Panel Report

Maribyrnong Planning Scheme
Amendment C122

2 December 2013

Figure 1 DPO16 Indicative concept plan.

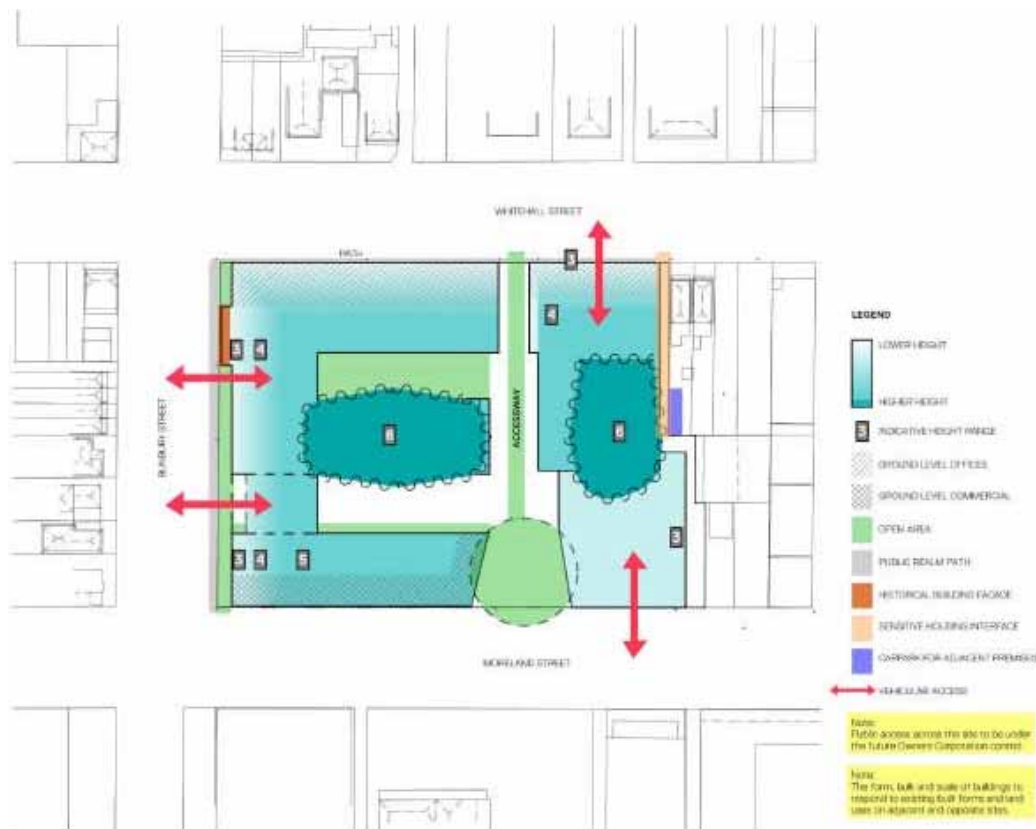
However, during the Hearing the Panel queried whether the very limited setback of the fourth level shown on the Bunbury Street section in Amendment application report (16 May 2013) would achieve the apparent design intent of more recessive upper levels. This section does not form part of the Amendment and the Panel is satisfied that the concept plan in DPO16 indicates a more generous setback of the upper levels from Bunbury and Whitehall Streets.

The Panel appreciates Mr Speth's concern that there could be departures from the concept plan in DPO16. However, the requirement that the Development Plan must be generally in accordance with a Concept Plan that forms part of DPO16 provides a greater level of certainty than often applies under a DPO. Furthermore, the Panel is satisfied that the proposed concept plan effectively illustrates an appropriate building envelope while maintaining some design flexibility.

Finally, the Panel notes that building height is expressed in terms of the number of storeys, rather than more specific reference to height in metres, which is often the preferred form of drafting. This drafting preference particularly applies where mandatory maximum heights are proposed, rather than nominating preferred heights, as is the case in DPO16. The Panel considers the less prescriptive reference to the number of storeys envisaged in different parts of the site in the DPO16 concept plan provides reasonable guidance on the scale of buildings to be accommodated.

At the hearing the Panel queried the implications for public access of the DPO16 requirement (under permit conditions) for the body corporate to manage open space identified in the Concept Plan. Council and the proponent confirmed that there is a clear expectation/intention for these spaces, and particularly the thoroughfare, to be publicly accessible at all times. The management of these spaces at night will require consideration during subsequent design and assessment processes. The Panel agrees with Mr Speth that the design of the open space at the Moreland Street frontage and the associated link through the site should contribute to the integration of the site with the arts precinct and will be critical to perceptions of whether it is attractive to potential users. The Panel considers the intent for this space is apparent in the framework provided by DPO16, however, it is one area where some additional guidance could be provided. Otherwise, the Panel considers DPO16 provides a sound basis on which to progress the design and development of the site.

Delete the qualification 'indicative' from that concept plan in DPO16.
